Agenda
for
99th PCC Meeting

EASTERN REGIONAL POWER COMMITTEE

AGENDA FOR 99TH PROTECTION SUB-COMMITTEE MEETING TO BE HELD ON 12.02.2021 AT 10:30 HOURS

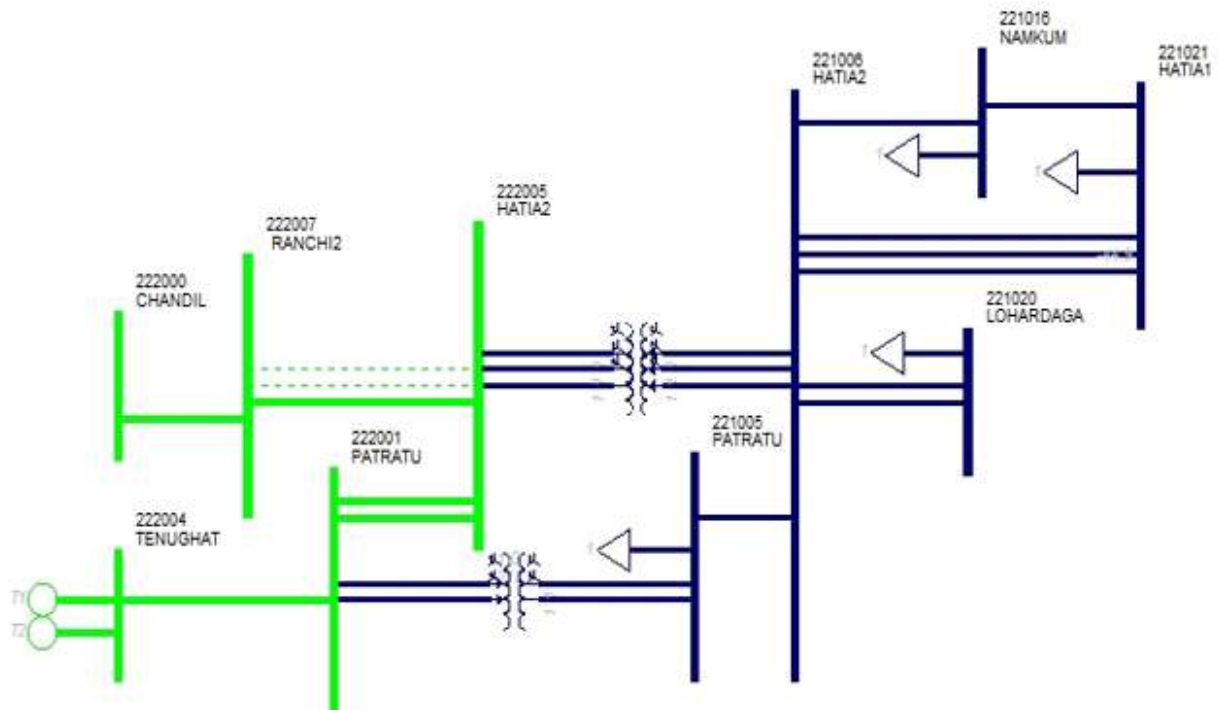
Following points need to be explained by concerned utility:

- a) As the line was charged through tie-breaker at Barh end such occurrence of grid disturbance could have been avoided if DT was not sent from Barh end. The reason for sending DT from Barh end during the event may be explained.
- b) The reason for non-reclose of B pole (faulted phase) of the main breaker at Barh may be shared.
- c) Breaker operation of tie-breaker is not captured by DR recorded at Barh end. The same may be implemented in DR output as unused channels are available.

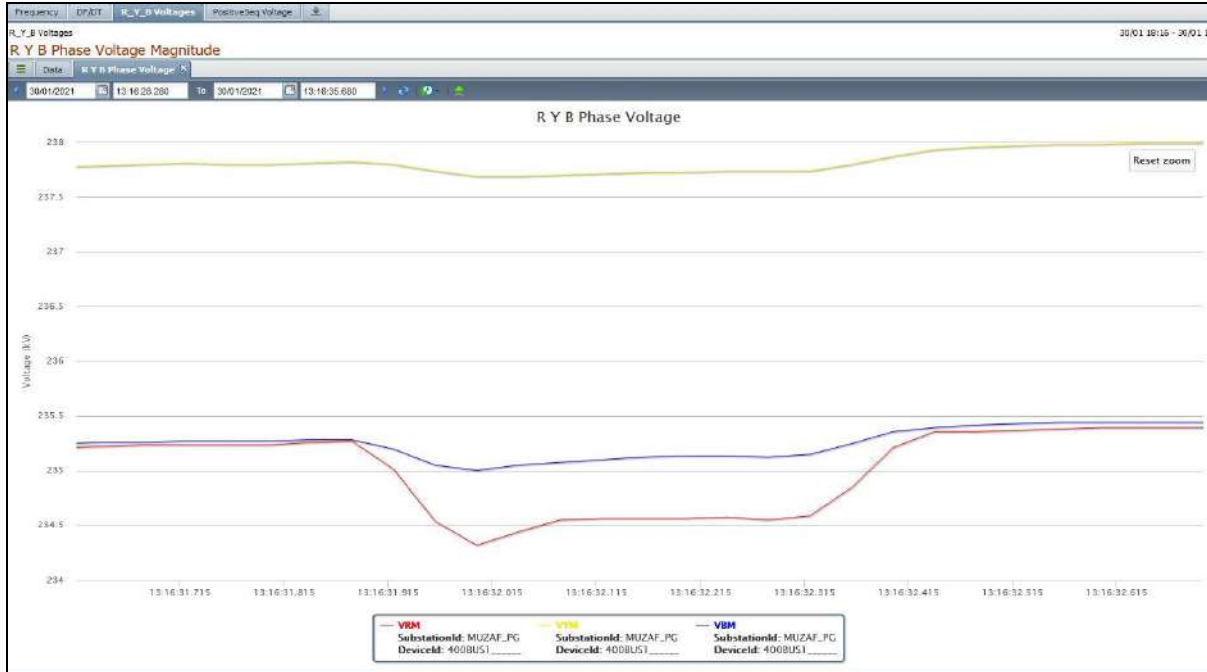
As per PMU data captured at Muzaffarpur, fault clearing time was around 450 ms.

The following points need to be explained by respective utilities:

- Location of fault.
- Reason for delayed clearance of fault
- Relay indication recorded at Betiah end for 132 kV Motihari Betiah – 2.

DR Patna end:

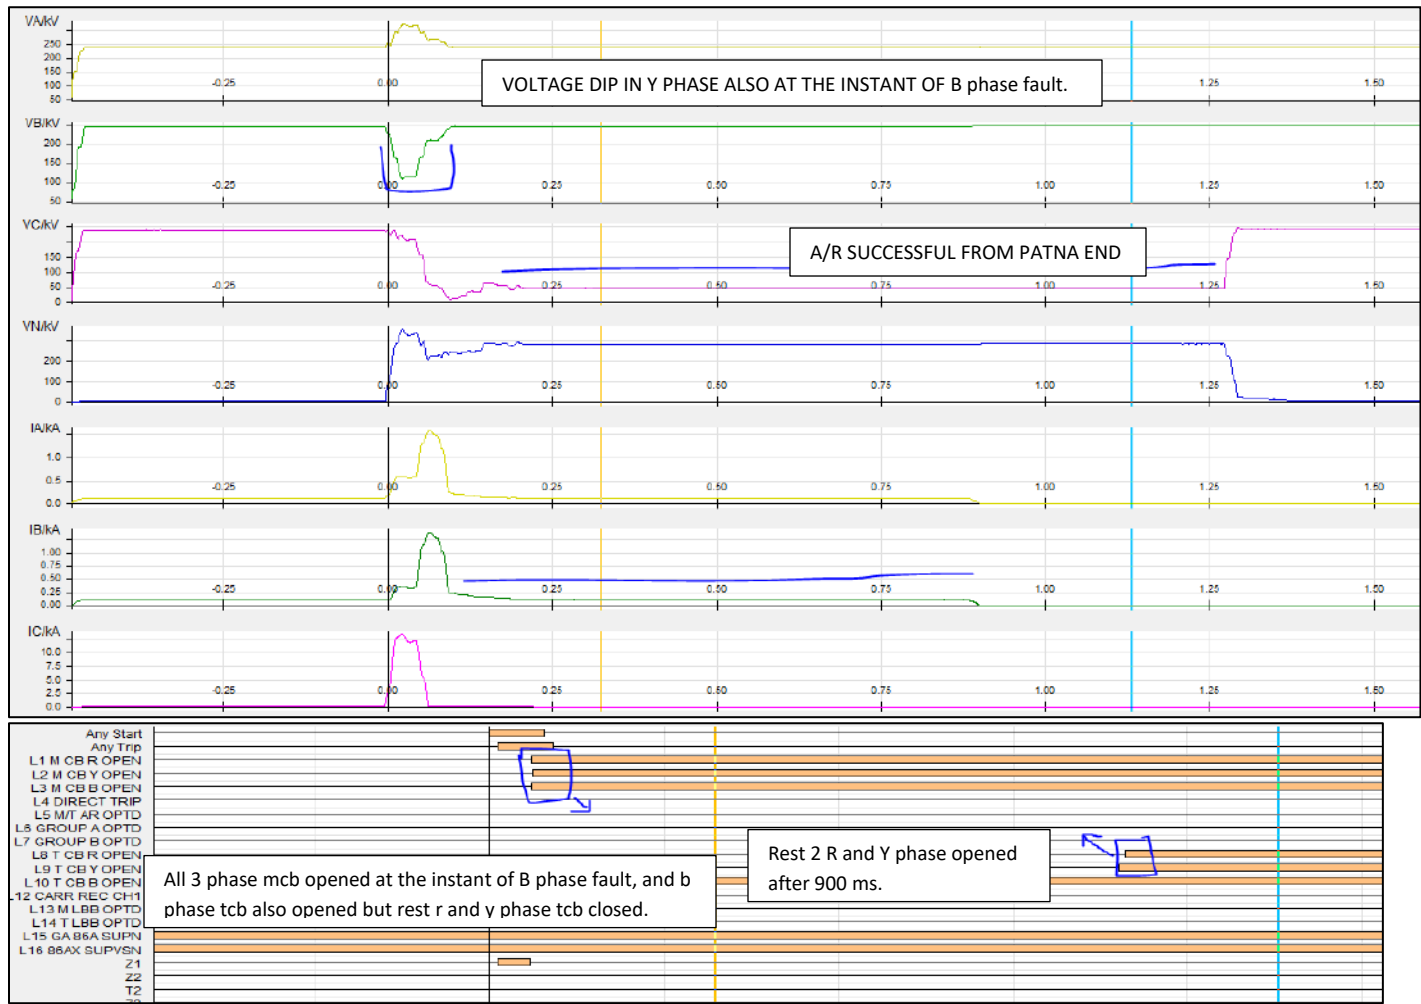
Similar event as previous ,There was B phase fault in the line and At Barh end , in Y phase huge dip observed and current in R &Y phase also increased upto 1.4ka, while R phase voltage increased momenterally upto 800 Kv.**While at Patna end no such voltage dip or increase observed** in any healthy phase. Earthing at BARh end may be checked properly . Reason for such phenomenon at Barh may be explained?

At Barh end all 3 phase mcb opened and only B phase TCB opened , rest Y and B phase TCB were closed which also got opened after 900 ms.why this occurred and why A/R did not operated? while At patna end A/R was successful .
